IRF22/4082

Plan finalisation report – PP-2021-3619

Canada Bay LEP 2013 - Parramatta Road Corridor
Urban Transformation Strategy – 2016 - 2023 release
areas

December 2022

Figure 6 – Post-exhibition incentive HOB Map for Kings Bay precinct (Base source: planning proposal)

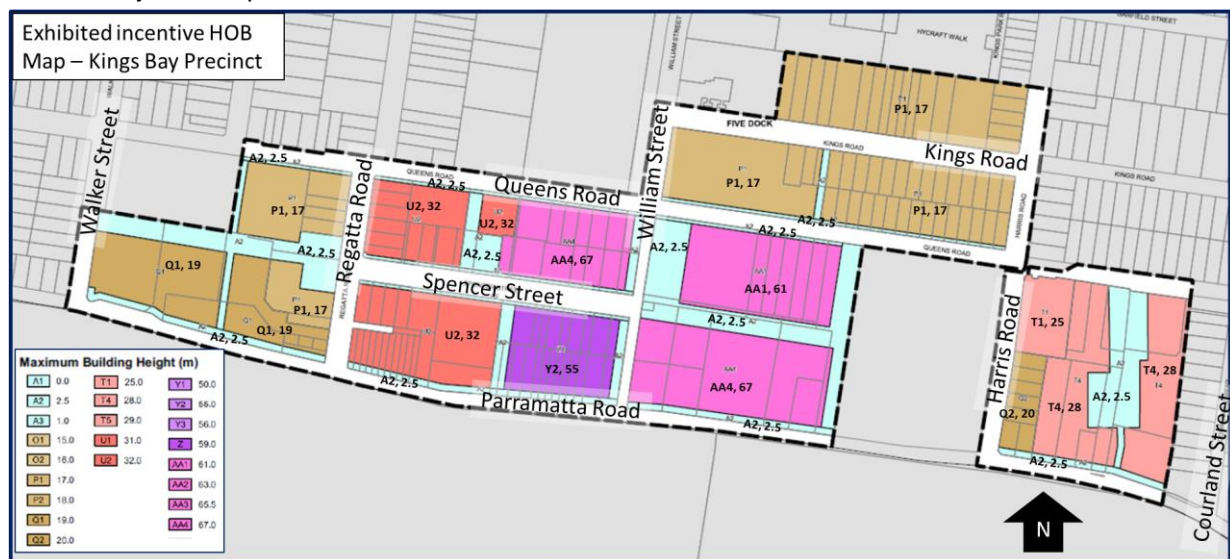
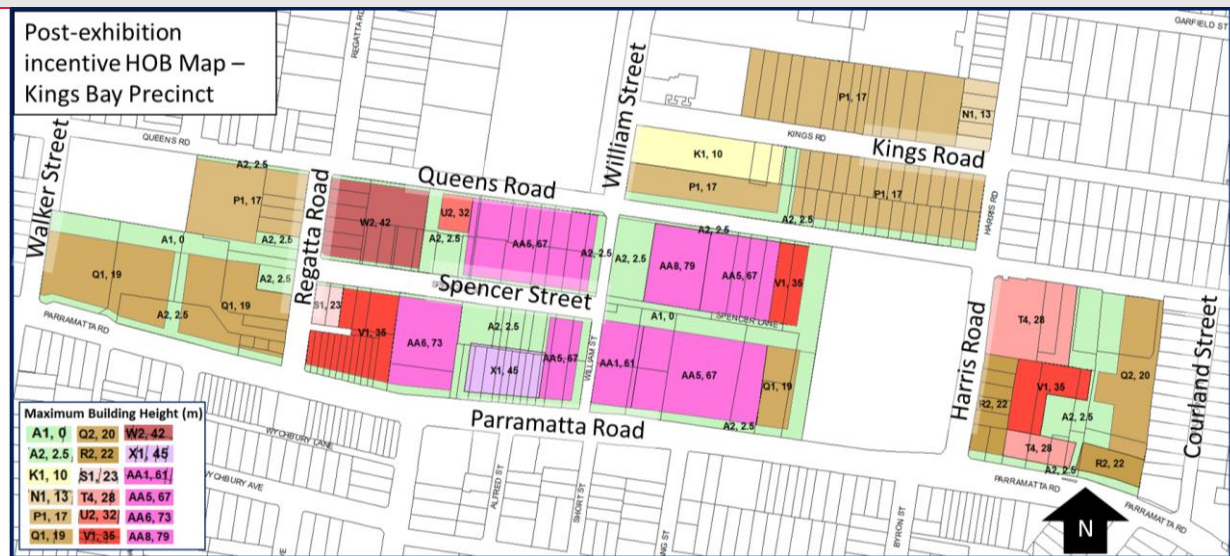
Council officers subsequently recommended various amendments to incentive heights and FSRs in the Burwood-Concord and Kings Bay precincts., This process has resulted in retention of exhibited development densities (i.e. FSR) with further refinement of building heights, with the exception of a limited number of sites, being:

- Key Site Map Area 5 - 1A Broughton Street, 55 and 57-59 Parramatta Road, Concord;
- Key Site Map Area 7 - 29-45 Parramatta Road, Concord;
- Key Site Map Area 9 - 19 Parramatta Road (Lot A DP 340812) 20 and 26 Burton Street, and 11 and 13 Burwood Road, Concord (Burwood North Metro Station Site); and
- Key Site Map Area 11 - 235 Parramatta Road, Five Dock.

Figure 10 – Post-exhibition incentive HOB Map for the Burwood-Concord precinct (Base source: planning proposal)

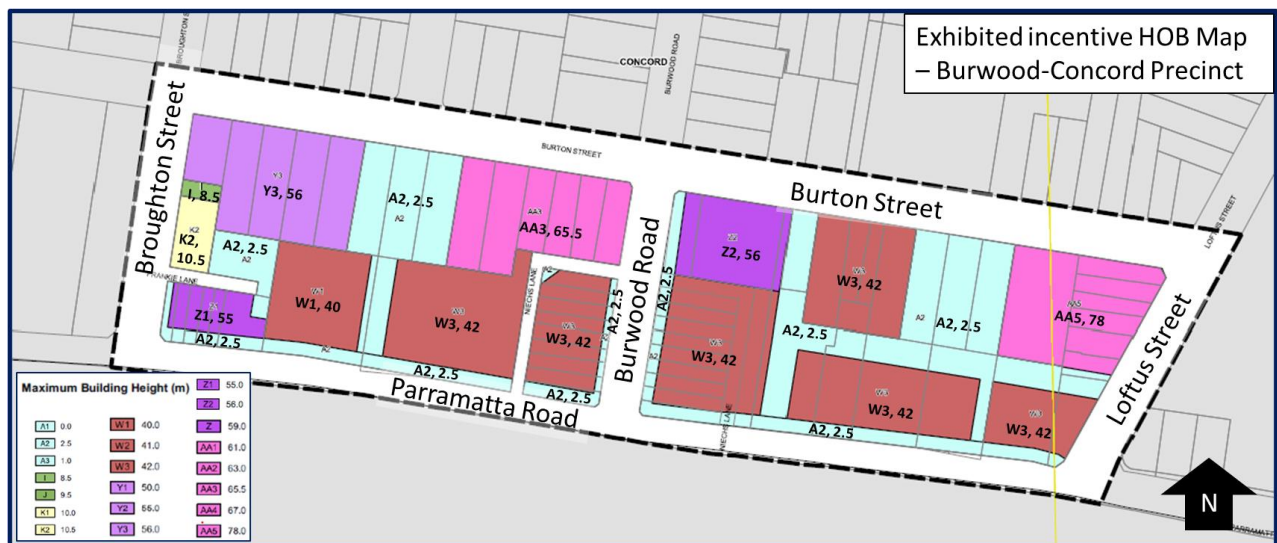
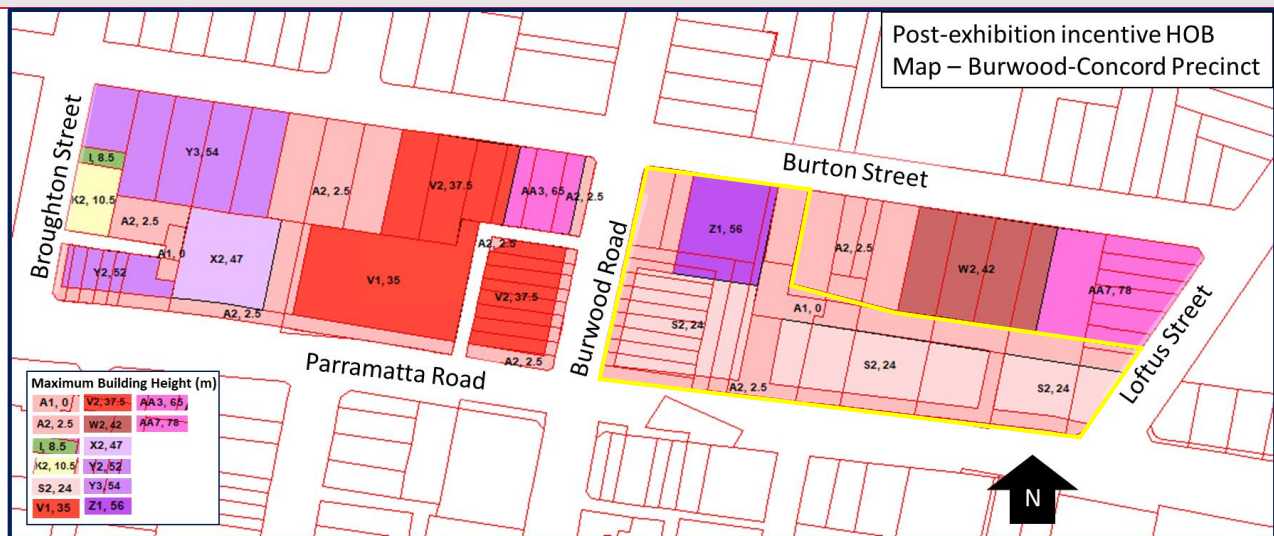
In response, Council recommended a reduced incentive FSR to the site and reduced incentive heights to part of the site (**highlighted yellow in Figures 10 and 12 on pages 22 & 23 above**)
